Misc Details: Intensive Green Roof / Overheating Risk / Slot Drain Detail

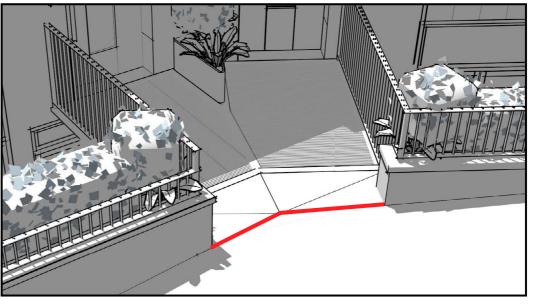
"Cooling hierarchy - SAP results show Medium overheating risk during summer months applicant should consider further measures to reduce overheating risk.

The windows and roof lights on the proposed development prone to the most constant direct sunlight, those shown principally facing SW (in blue), will incorporate Solar Control Glass such as Pilkington Activ Suncool, Pilkington Activ SunShade or an equivalent. Glazing on the rear facade facing principally facing west, only gets direct sun towards the later part of the day. All windows on the front facade only get direct sunlight for a limited time in the early morning.
